ADDRESS: 418 SPRUCE ST

Proposal: Renovate rowhouse; construct addition

Review Requested: Final Approval

Owner: Society Hill Synagogue

① Spruce Street Elevation
1/8" = 1'-0"

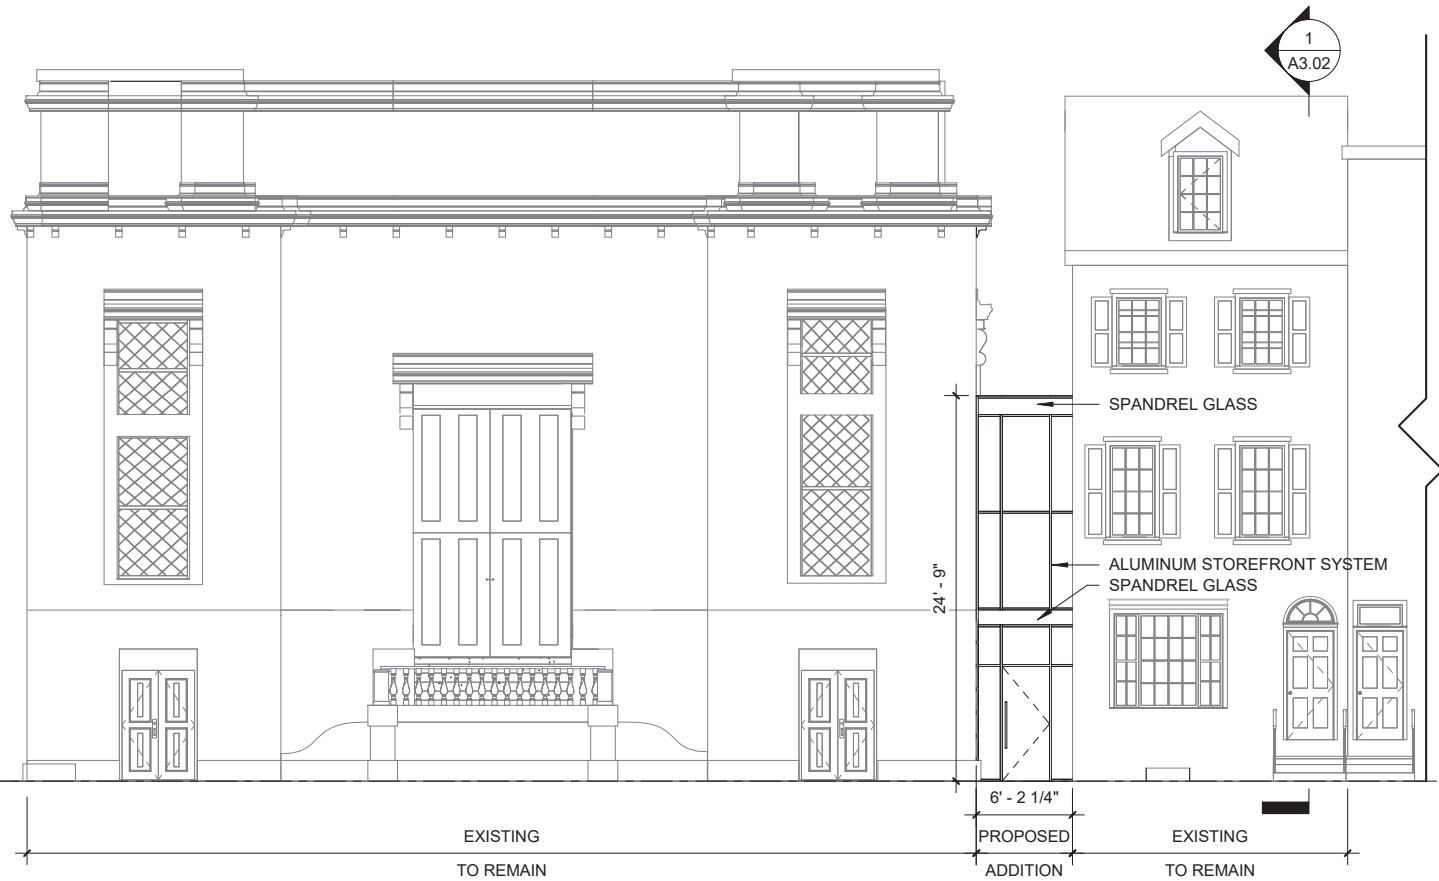
- The height of the glass and aluminum link is shorter than the synagogue and rowhouse.
 - The front elevation of the proposed link is set back from the front elevations of the synagogue and rowhouse.

- The proposed materials differentiate the two-story link from the historic masonry of the two buildings.
- *Standard 10: New additions or adjacent or related new construction will be undertaken in such a manner that, if removed in the future, the essential form and integrity of the historic property and its environment would be impaired.*
